# STAFF RECOMMENDATION

NCPC File No. 6744

**WHITE OAK FEDERAL RESEARCH CENTER  
FOOD AND DRUG ADMINISTRATION  
BUILDING 1, ENTRY PAVILION AND PERIMETER SECURITY  
Montgomery County, Maryland**

Submitted by the General Services Administration

Building Section at Security Pavilion

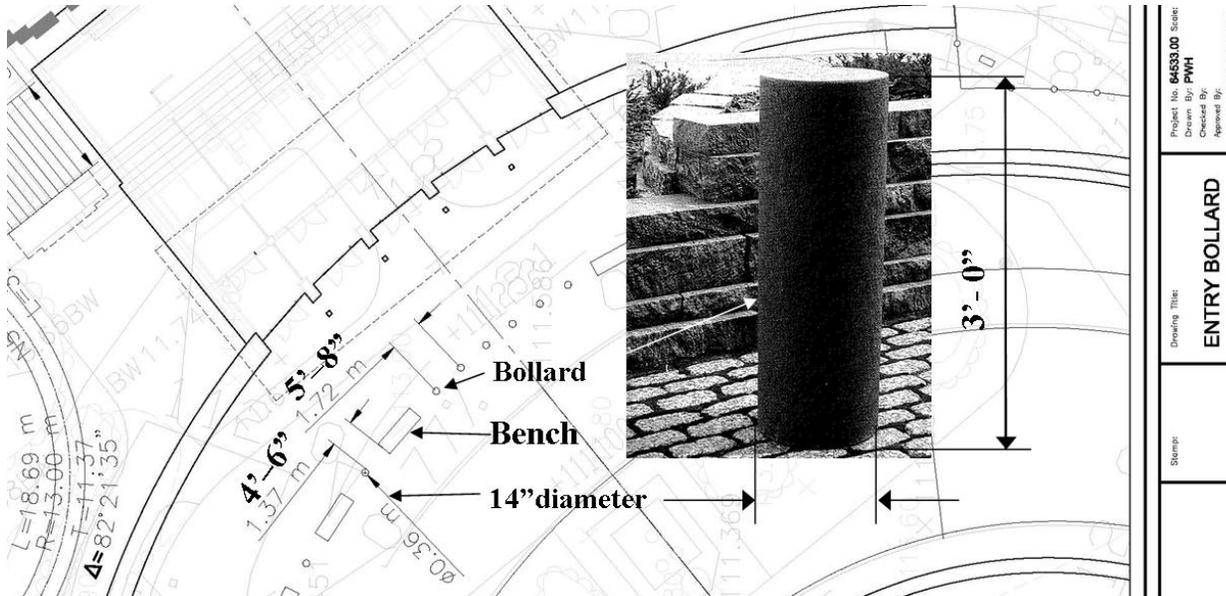
The applicant has stated the design intent of preserving the historic character of the building as outlined in the MOA with the MD SHPO and in the HBPP. Staff is satisfied that the design for renovating Building 1 and that the proposed security pavilion follows the intent of the MOA, which acknowledges that the design should modify the front entrance of the remaining portion of Building 1 to provide a visitor's entrance from the basement underneath the current entry steps and decks. Providing an entry pavilion underneath the existing entry as proposed will allow security screening to occur outside the building footprint while also providing an accessible entry for those with physical disabilities. The link space directly behind Building 1 shows proper deference in height by measuring slightly lower than the Building 1 roofline.

Revised Detail of Bollard Size and Spacing

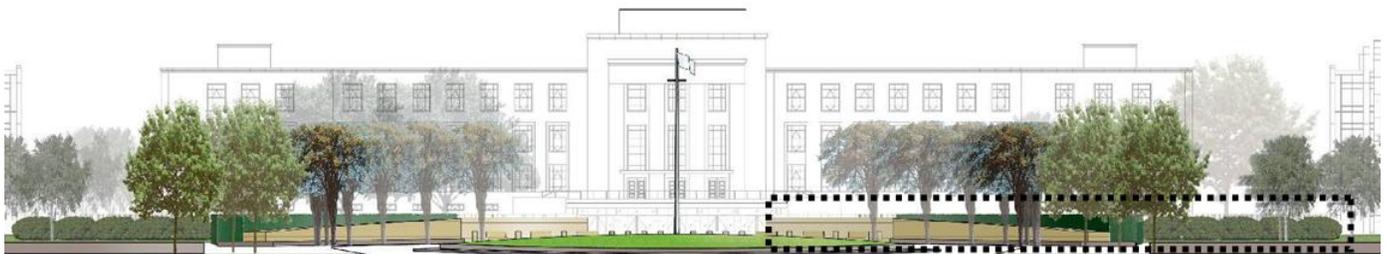
As NCPC approval of preliminary site and building plans required of the final submission, more fully detailed plans and details of the perimeter security elements have been included. This brought to staff's attention that bollard diameter (16 inches) had almost doubled from the diameter (9 inches) shown in the preliminary submittal. The height remained 42 inches high, and the spacing was not defined. Based on staff input and comment during the review, GSA has agreed to decrease bulk and height and employ a wider spacing between bollards, and has confirmed a bollard diameter of 14 inches, a height of 36 inches, and spacing of 5'-8" on center with 4'-6" openings between bollards and benches. GSA provided the following revised details:

The perimeter security portion of this project has been revised such that details and descriptions of the massing, material and dimensions including wall heights and bollard diameters are acceptable. Drawings clearly show the proposed security measures in the context of the surrounding buildings, including retaining walls at the Loop Road and the eight-foot high black steel pipe security fence. Although staff does not expect the security fence to be completely hidden by the proposed yew hedge for several years, it has been designed to blend into the background rather than to stand out. Material and color samples for building and site elements have been submitted, including granite cladding. Staff now finds that information submitted in the perimeter security portion of the project is acceptable to convey its intent and therefore recommends final approval.
